## **ARTICLE II. BUILDING CODE\***

**Sec. 5-26. International Building Code-Adopted.** The International Building Code, 2009 Edition and appendixes chapters E, F, G, I and J as published by the International Code Council, Inc. a copy of which is on file in the office of the City Secretary, as amended by Section 5-27 and administered and enforced by the office of the Building Official is hereby adopted by reference and designated as the Building Code of the City as though such code were copied at length in this article.

**Sec. 5-27. Same-Deletions and Amendments.** The building code adopted in this article is hereby amended and changed in the following respects:

FIGURE R602.6.1  
TOP PLATE FRAMING TO ACCOMMODATE PIPING

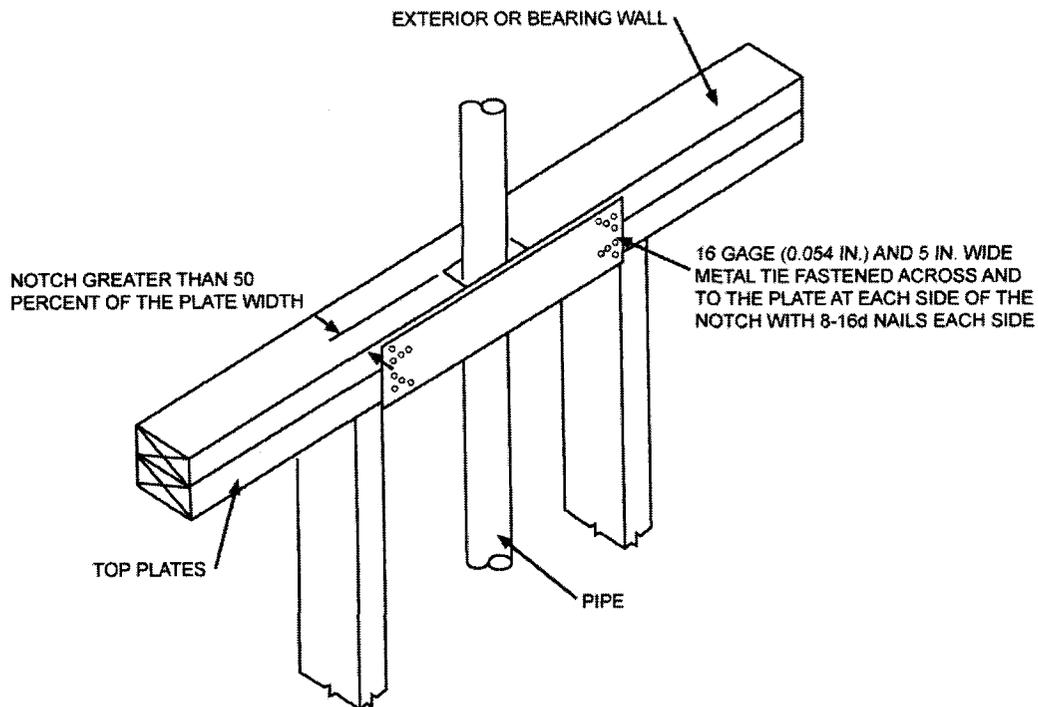
**\*\*\*Figure R602.6.1; delete the figure and insert the following figure:**
